## Meeting Minutes

Project: City of Wichita Fire Station 23  
City of Wichita  
Wichita, Kansas

Subject: Schematic Plan and Exterior Concepts

A FIRST FLOOR PLAN  
 1/8" = 1'-0"

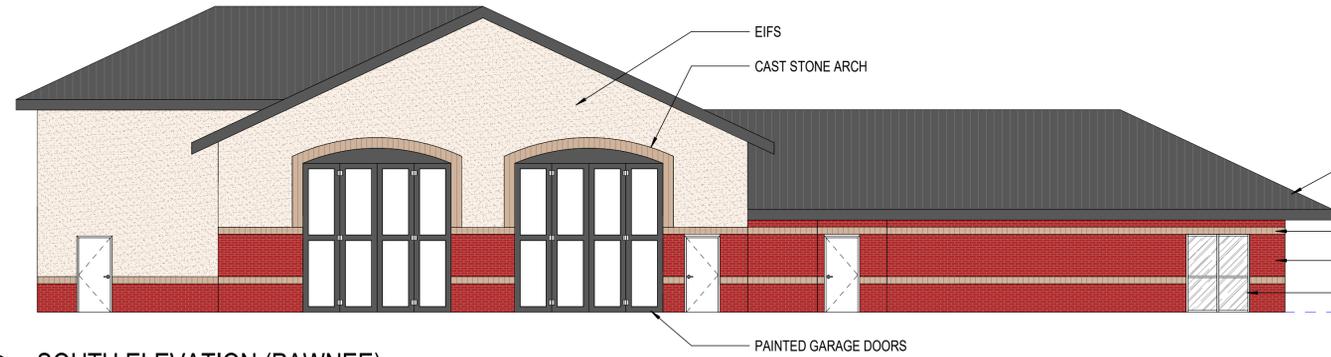
- (b) Discussed Plan Changes:
    - 1) Consensus by Committee to reduce women's lockers square footage to accommodate up to six lockers.
    - 2) The Committee has decided to remove the training/storage mezzanine. This will lower the roof height above the apparatus bay support spaces. A mechanical mezzanine will still be included above the support spaces, which will provide heating for those spaces and prevent the need for placing HVAC equipment on the exterior.

- 3) The workroom will reduce the number of workstations from three to two and the space will be resized proportionally. Any space that is reduced from the workroom is preferred to be given to the kitchen space.

- 4) The shower in the public restroom will be plumbed in, but not finished out.
    - 5) TESSERE will look into reducing the alcove for the drinking fountains in the entry vestibule while maintaining ADA clearances and egress requirements.

- 6) The interior and exterior double doors serving the fitness space can each be replaced with a single 4-foot door.
    - 7) Align IT and restroom south walls to avoid offset.

- 8) The desire by the Committee is to have the north end of the decontamination (decon) spaces flush with the north side of the apparatus bays. The SCBA space and the medical storage space can be reduced and reconfigured to allow this. The only equipment in the SCBA room will be the compressor. The medical storage can be replaced with cabinet storage and relocated closer to the riser space.

- 9) The Committee decided to make the covered patio space part of a design alternate at the time of construction bidding. If no patio is built, an exterior sidewalk on the east side of the building will be created. Alternatively, the patio fence may be able to be included as the art portion of this Project. TESSERE will continue to look into options regarding the patio and the art component.

3 NORTH ELEVATION  
1/8" = 1'-0"

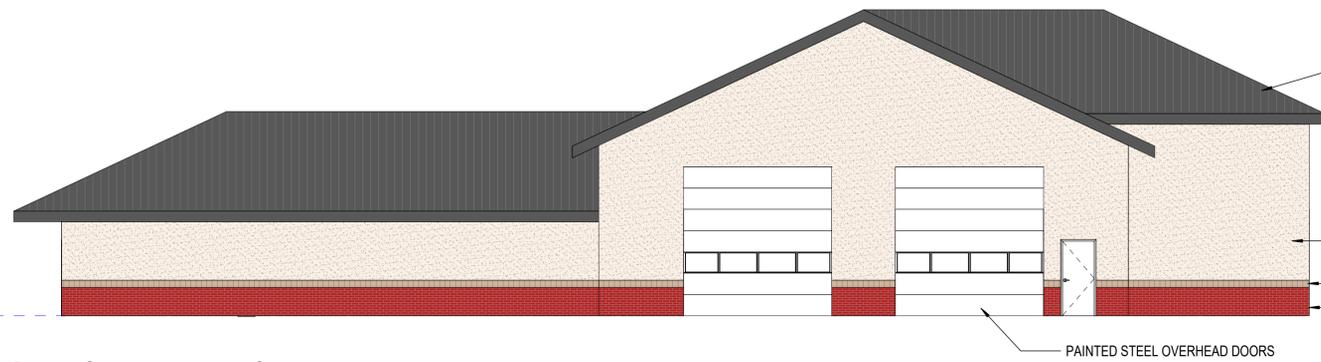
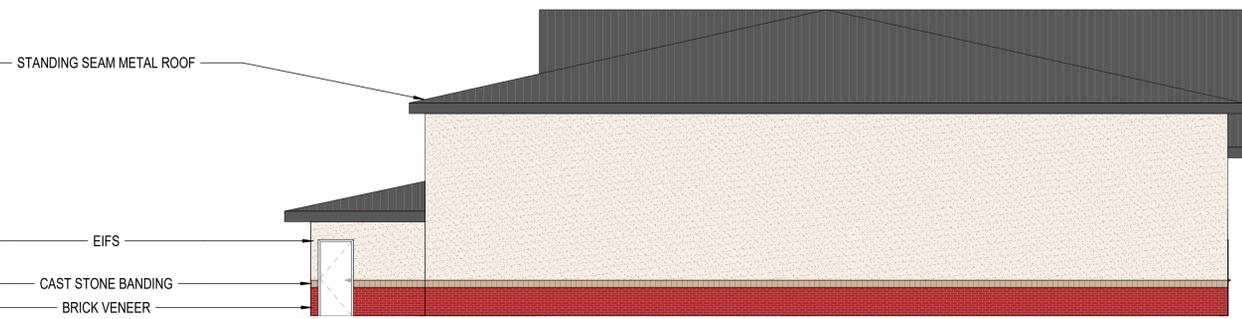
- b. Exterior – Elevation and Color:
  - (1) Decisions:
    - (a) Consensus by Committee to include brick wainscot on the north and west elevations. A design alternate would be to remove this brick and alternatively install high-density foam exterior insulation and finish system (EIFS).
